Subject: AP1000 Responses to Requests for Additional Information (SRP3.10)

# AP1000 TECHNICAL REPORT REVIEW

RAI Response Number: RAI-SRP3.10-EMB-05  
Revision: 0

Figures 1 through 6 provide examples of test data which demonstrate frequency content in the 25 Hz to 50 Hz range.

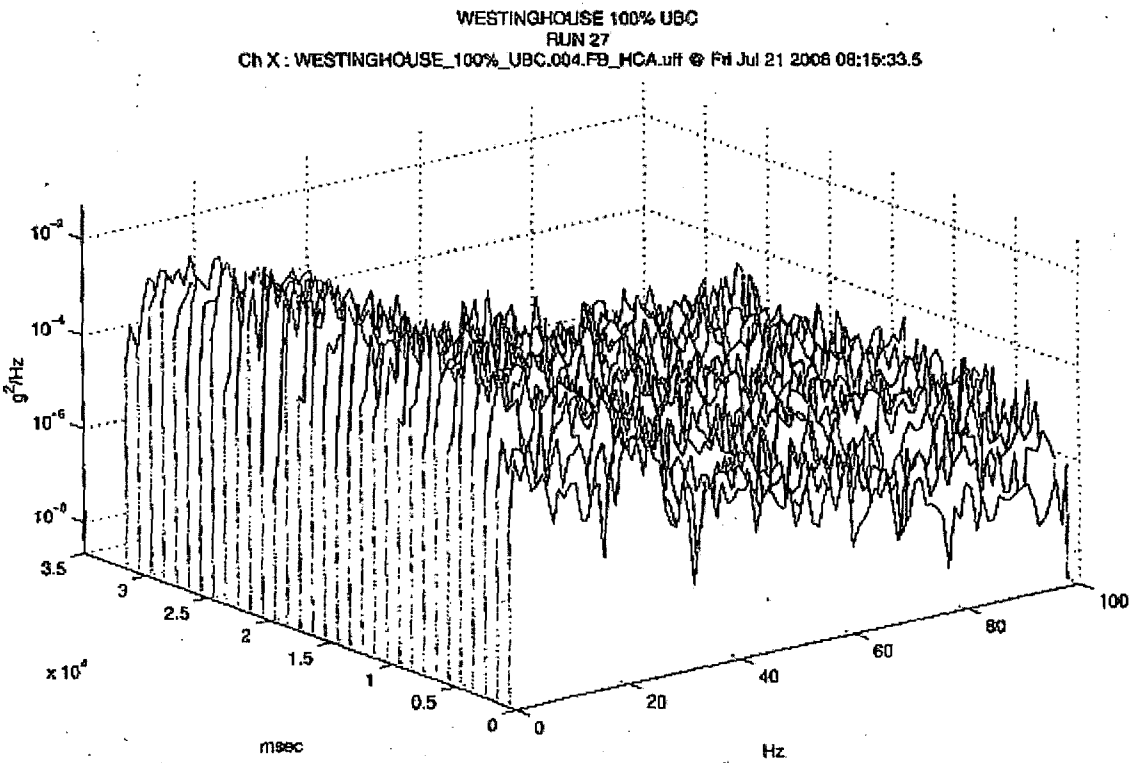
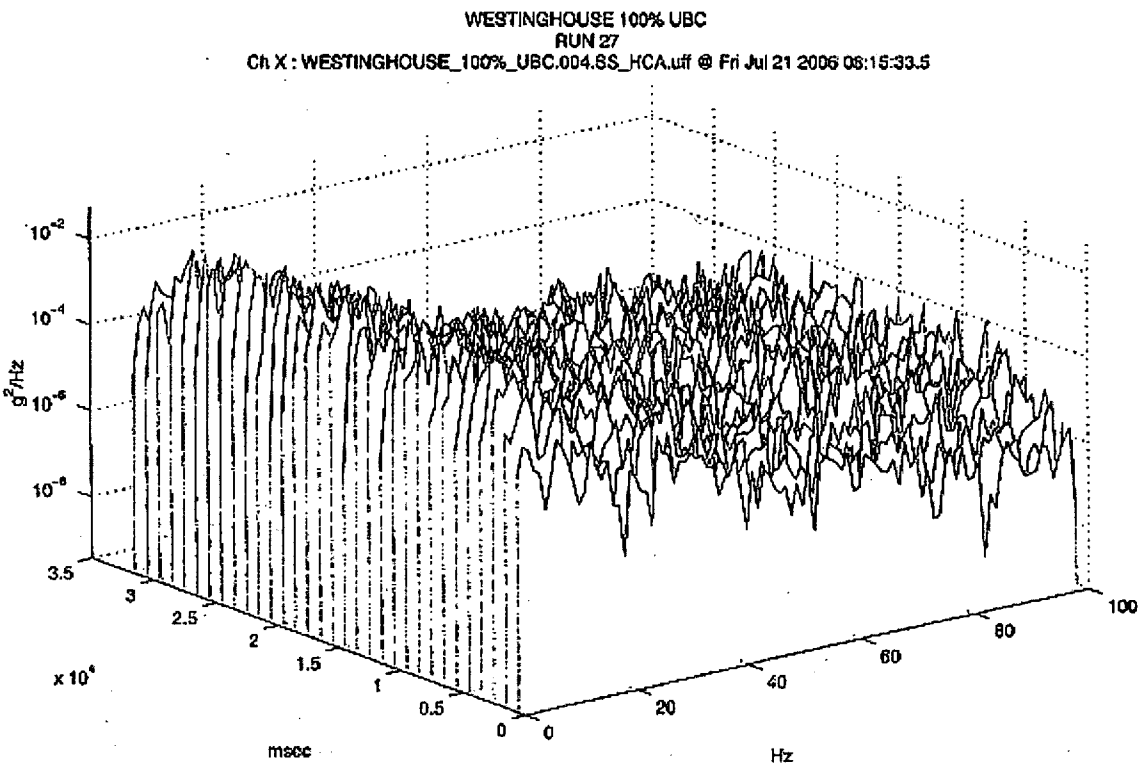
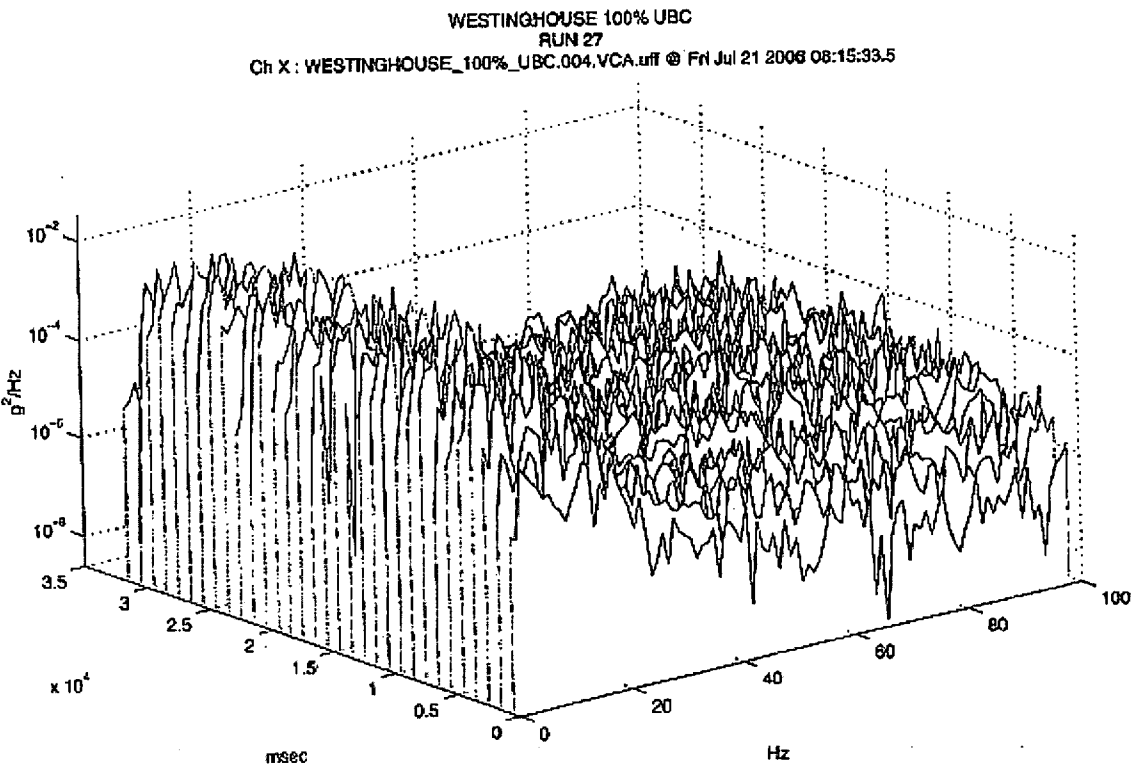
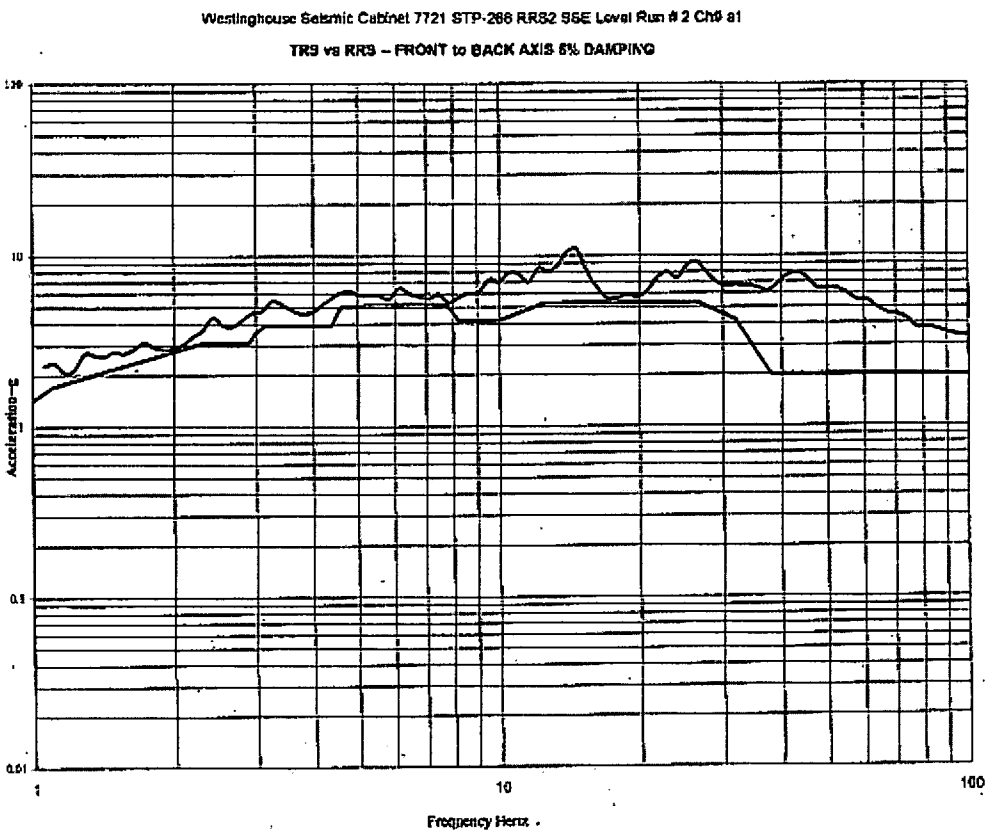
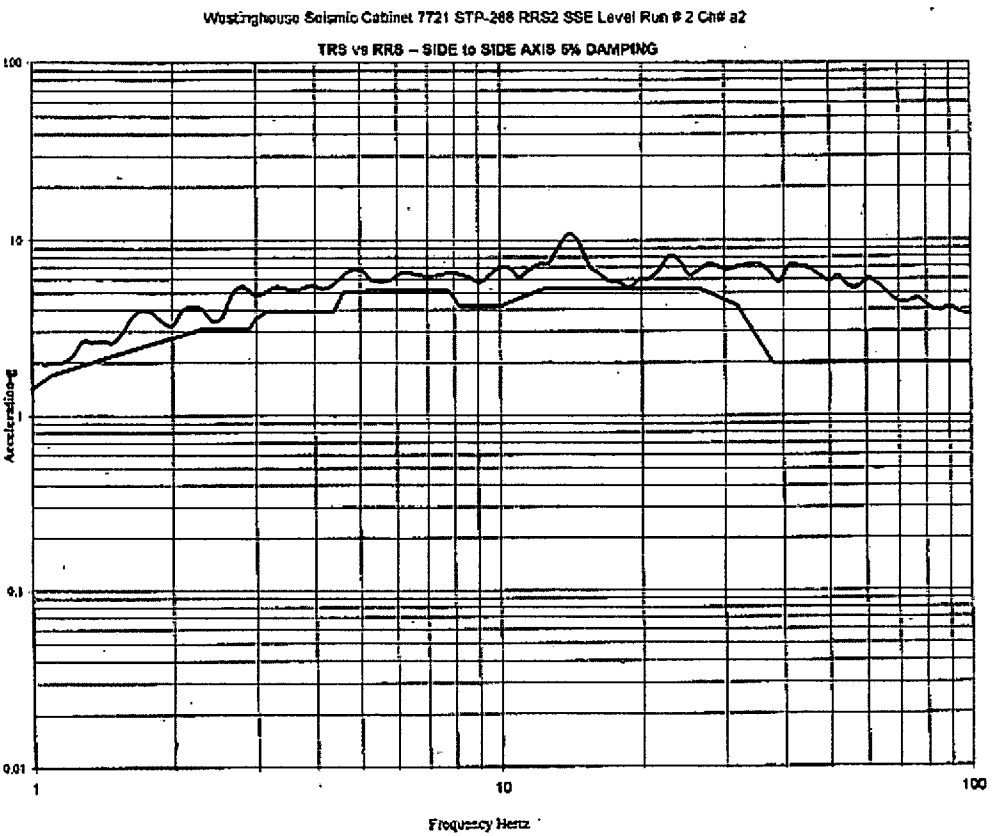
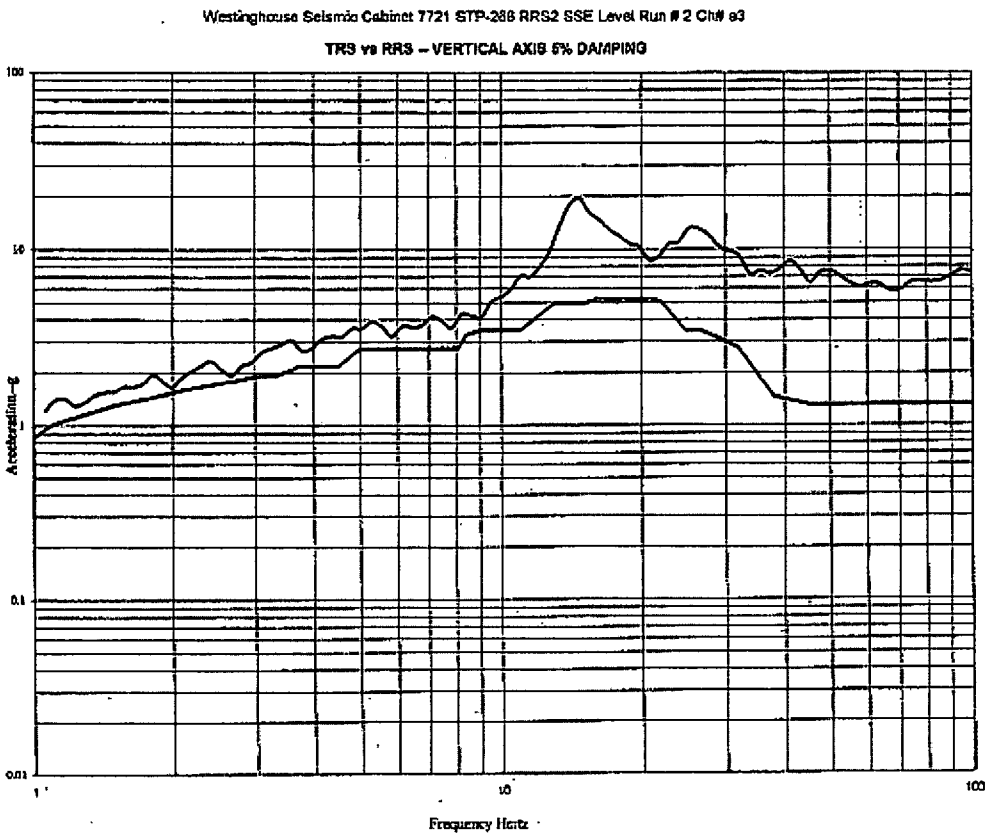
What are the justifications for the conclusion addressing use of existing test data in Sections 6.4.1 and 6.4.7 (Summary and Conclusion)? Most of the existing qualification test data were obtained using frequency inputs to the shake table up to 33 Hz. The test response acceleration of 2.0g (zero period acceleration at 5 percent critical damping) shown in the existing test data obtained from the low frequency (less than 33 Hz) seismic tests may not represent the actual response acceleration of the electrical/electronic equipment/components with natural frequencies higher than 33 Hz, when the RRS contains the required frequency input higher than 33 Hz. In order for the existing data to be valid for resolving HF concerns, the adequacy of the time history or the adequacy of the frequency contents and the stationarity of the frequency contents of the synthesized waveform used for the shake table tests must be shown to be compatible with the amplified region of the RRS at high frequencies. IEEE 344-1987 requirements must be met.

The conclusions reached were based the information presented in Section 6.4.4 (Review of Existing Seismic Test Data). We believe this test data conservatively demonstrates that multiple frequency seismic testing in accordance with IEEE Std 344-1987 requirements to a spectral level of 2.0 g's (at 5% critical damping) in the 25 Hz to 50 Hz frequency range will not impact the structural integrity and functional operability of the equipment where it has been shown to be acceptable through seismic testing up to 33 Hz. The 2.0g level is considered an upper bound base input for functionality of equipment without further testing or evaluation. The test inputs typically included energy content up to 100 Hz.

Power Spectral Density (PSD) and other acceptable evaluation methods as defined IEEE Std 344-1987 are ways of determining energy content within a seismic test run. When available, PSD plots were used to evaluate seismic test data reported in Section 6.4.4 of AP1000 TR-115. For the test data reported, energy content in the 25 Hz to 50 Hz frequency range was demonstrated by meeting at least one of the following criteria:

1. Test report stated that the seismic time history inputs were developed with content in the frequency range up to 50 Hz as a minimum.
2. The test response spectra (TRS) were shown to be amplified in the 25 Hz to 50 Hz frequency and were not caused by impact or test unit rattling.
3. PSD plots indicate energy content in the high frequency region.
